CITY OF SOMERVILLE, MASSACHUSETTS
MAYOR'S OFFICE OF STRATEGIC PLANNING & COMMUNITY DEVELOPMENT
JOSEPH A. CURTATONE
MAYOR

Your application for a *de minimis* revision to your approved plans at 56 & 61 Clyde Street, case number PB 2008-07-DC1 (4/2013), has been accepted.

The attached elevations approved by the Planning Board on 1/6/2011 have been marked up to identify façade changes made during the construction phase. Elevations A201 and A202 were marked up by Planning Staff during inspection for the issuance of the Building A temporary Certificate of Occupancy. All other elevations have been marked up by ICON Architects.

MAXPAC
SQUARE

A-203

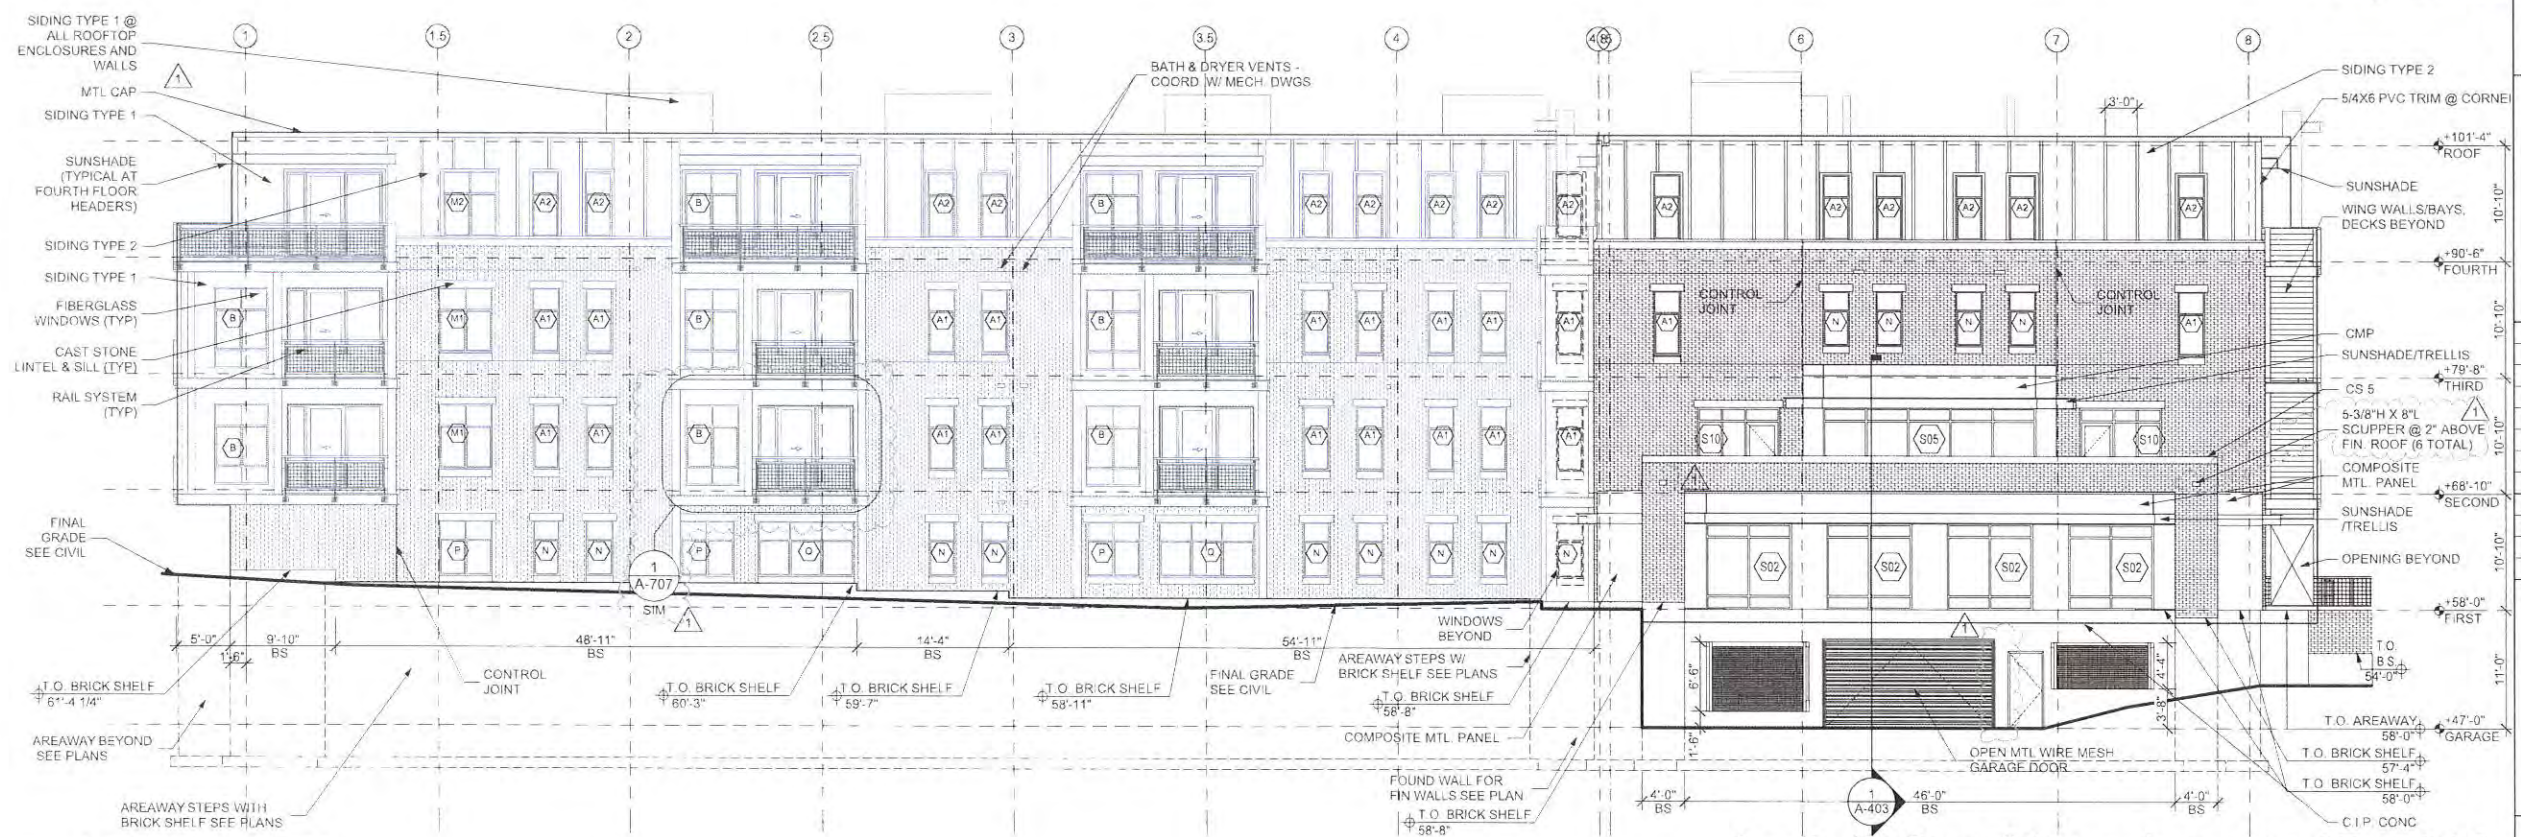
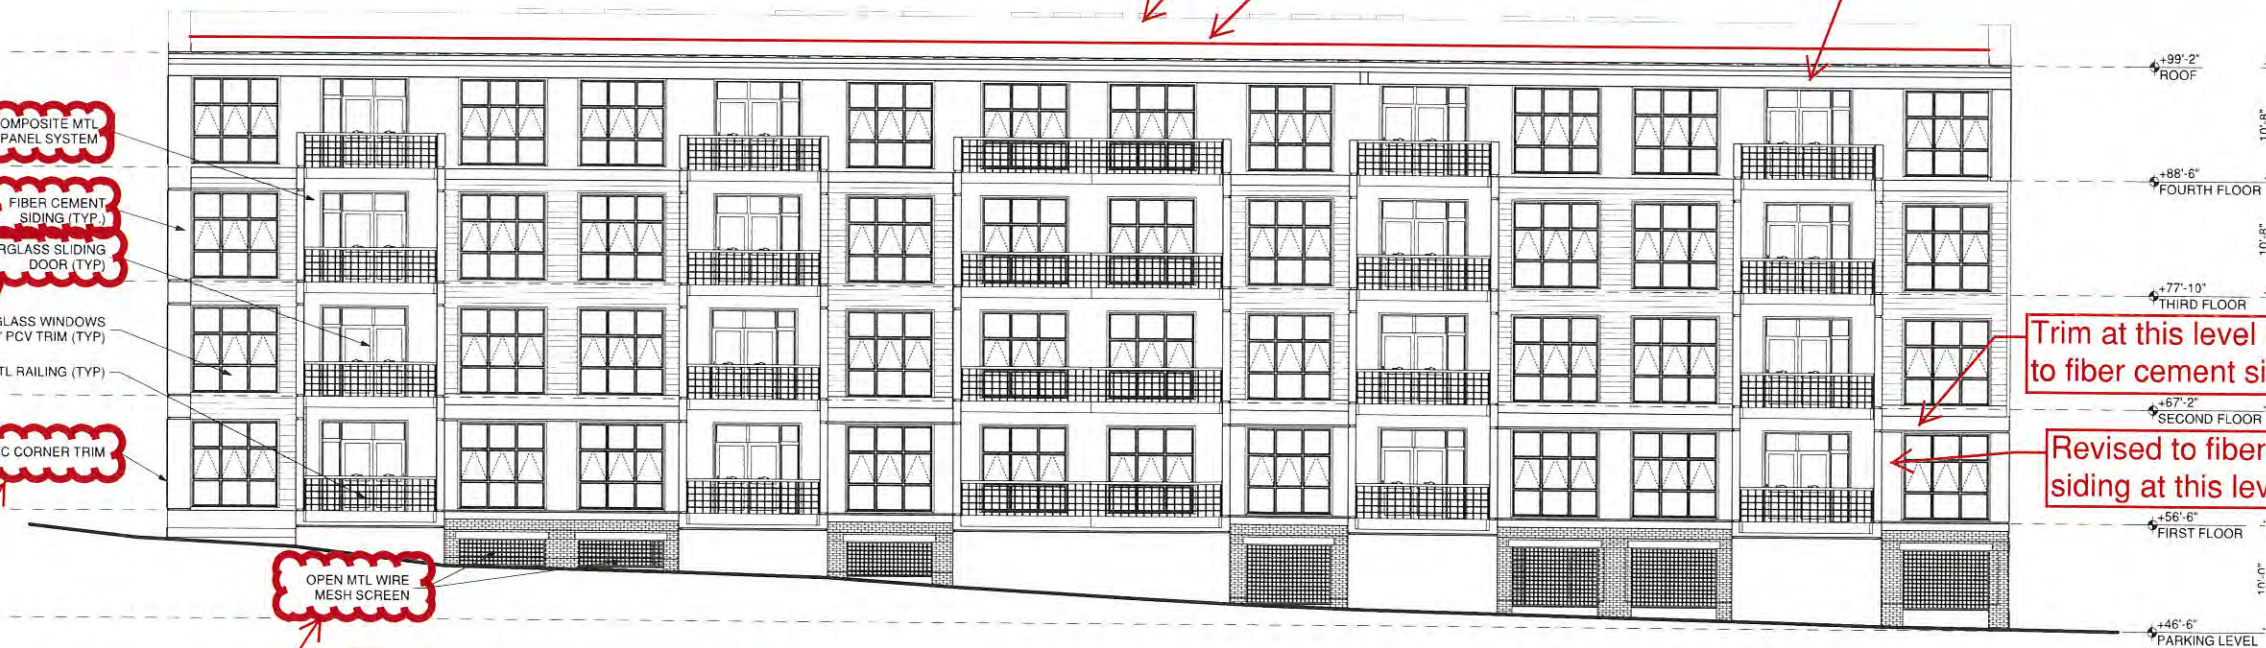
Mech. screen walls revised to multiple walls/shorter lengths

Small section of sloped roof added

Depth of composite metal panel increased

Sliding glass door assemblies revised to single sliding glass door w/o transoms or sidelite (typ. at all)

Grade adjacent to bldg revised. Less exposed foundation wall

Double windows revised to triple windows.

Material Clarified

Sliding glass door assemblies revised to single sliding glass door w/o transoms or sidelite (typ. at all)

Material Clarified

Extent of open mesh wire screen increased

Mech. screen walls revised to multiple walls/shorter lengths

Small section of sloped roof added

Depth of composite metal panel increased

A-205

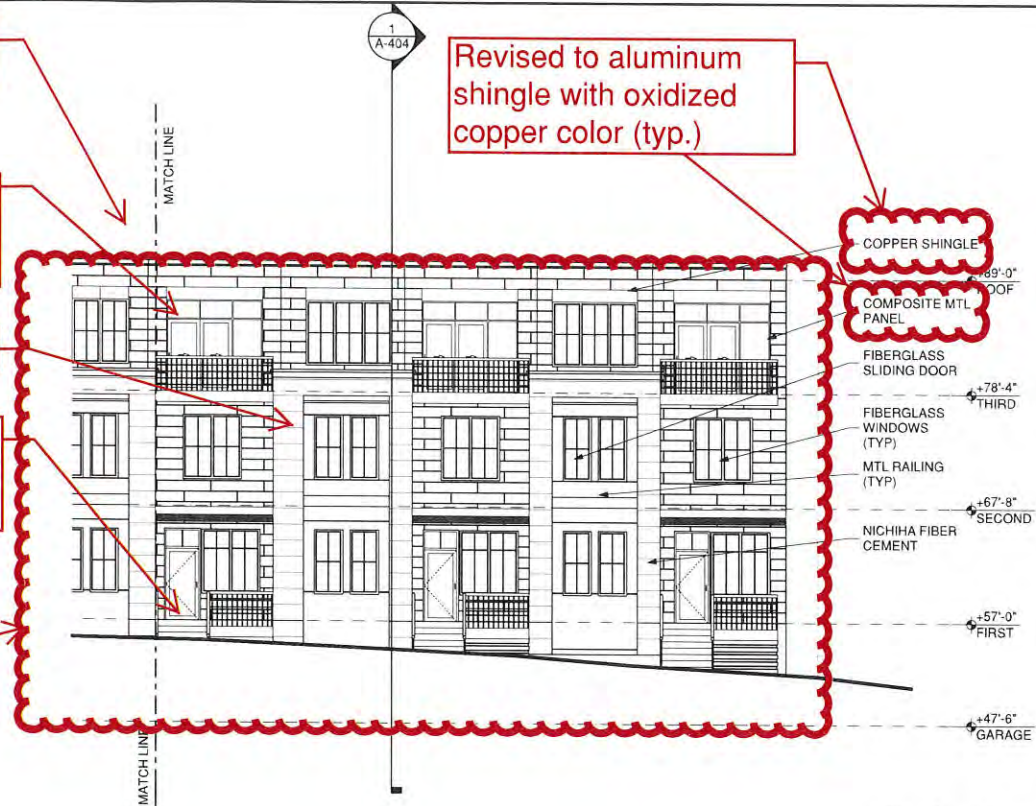
Mech. screen walls revised to multiple walls/
shorter lengths.

Sliding glass door assemblies revised to single
sliding glass door w/o transoms or sidelite (typ.
at all)

Trim added at fiber cement siding at bays (typ.)

No porches similar to west elevation at east
elevation. Sliding glass doors and at-grade
patios with railings at east elevation

Locations of bays revised throughout east
elevation

Revised to aluminum
shingle with oxidized
copper color (typ.)

Mech. screen walls revised to multiple walls/
shorter lengths.

Sliding glass door assemblies revised to single
sliding glass door w/o transoms or sidelite (typ.
at all)

Trim added at fiber cement siding at bays (typ.)

Locations of bays
revised throughout
east elevation

Grade adjacent to bldg
revised. Less exposed
foundation wall

Wall openings eliminated

Entry revised, storefront at each
side of door.

A-206

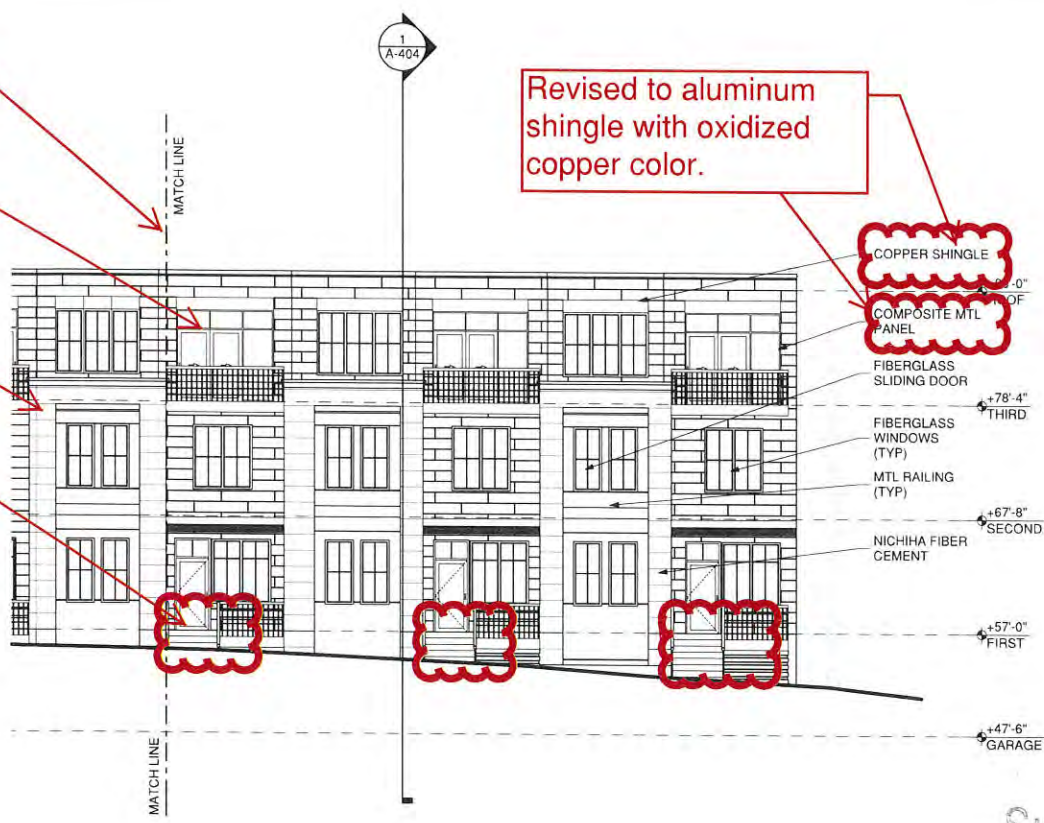
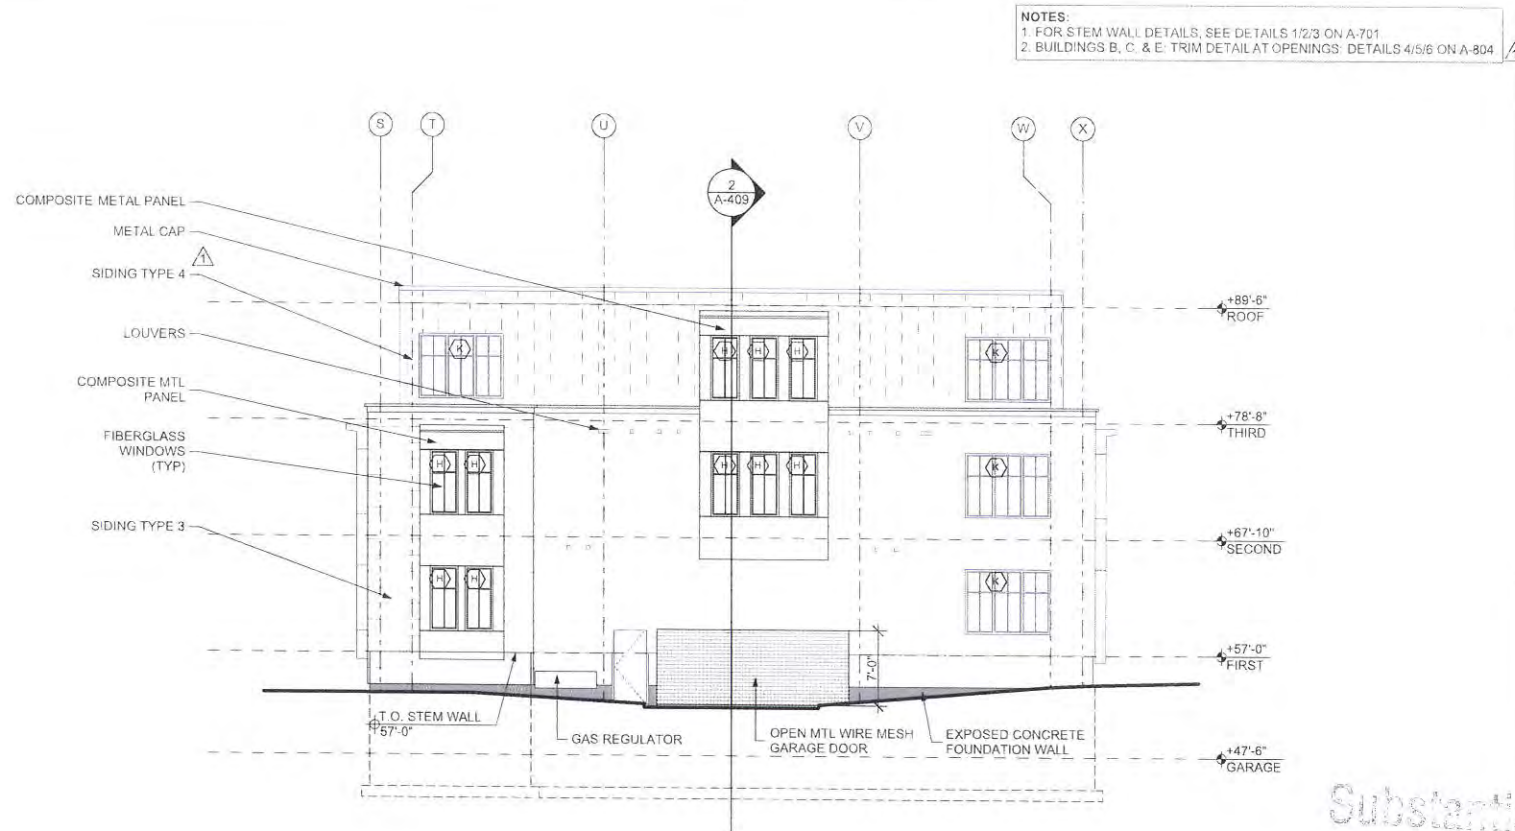
Mech. screen walls revised to multiple walls/
shorter lengths.

Sliding glass door assemblies revised to single
sliding glass door w/o transoms or sidelite (typ.
at all)

Trim added at fiber cement siding at bays (typ.)

Stair orientation revised at each townhouse
entry

Revised to aluminum
shingle with oxidized
copper color.

Mech. screen walls revised to multiple walls/
shorter lengths.

Sliding glass door assemblies revised to single
sliding glass door w/o transoms or sidelite (typ.
at all)

Trim added at fiber cement siding at bays (typ.)

Window trim added

Bay revised. Size
reduced. Location
revised. Windows
revised from triple
to double windows.

Grade adjacent to bldg
revised. Less exposed
foundation wall

Wall openings eliminated

Revised to fiber
cement siding

Entry revised, storefront size
increased.

A-207

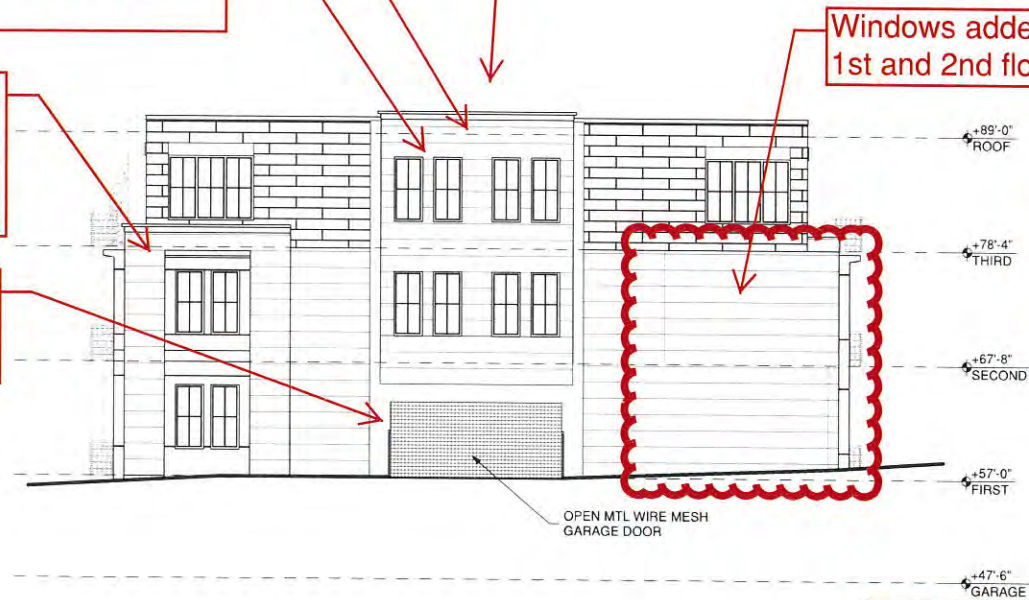
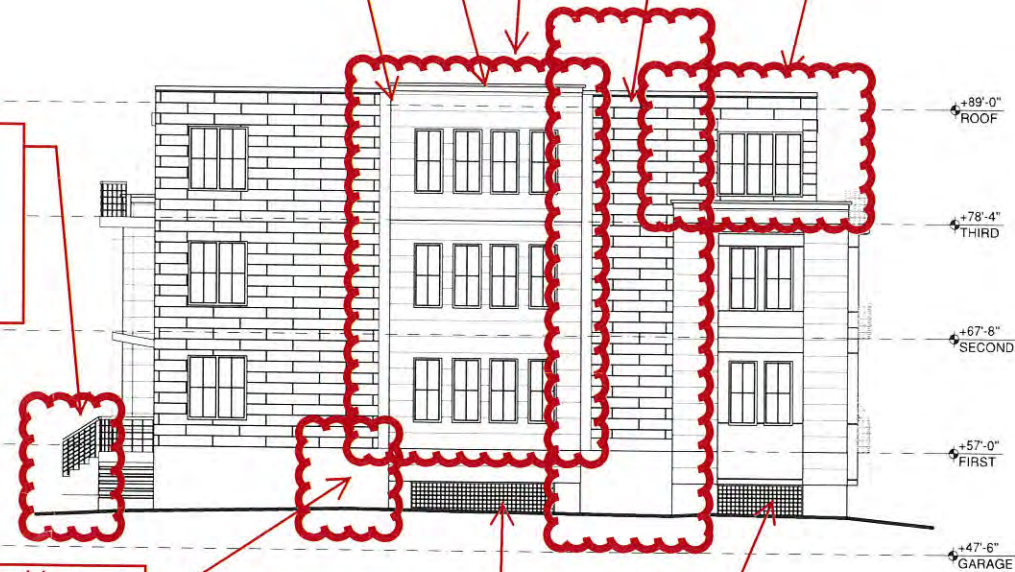
Mech. screen walls revised to multiple walls/
shorter lengths.

Trim added at fiber cement
siding at bays (typ.)

Size of bay reduced.
Number of windows
decreased from 4 to 3 at
each floor

Trim added at
fiber cement
siding at bays
(typ.)

Trim around
bay and door
revised

Mech. screen walls revised to multiple walls/
shorter lengths.

Bay narrowed. Number of windows
reduced from 4 to 3 per floor.

Trim added at fiber cement
siding at bays (typ.)

Stair
orientation
revised at
each townhouse
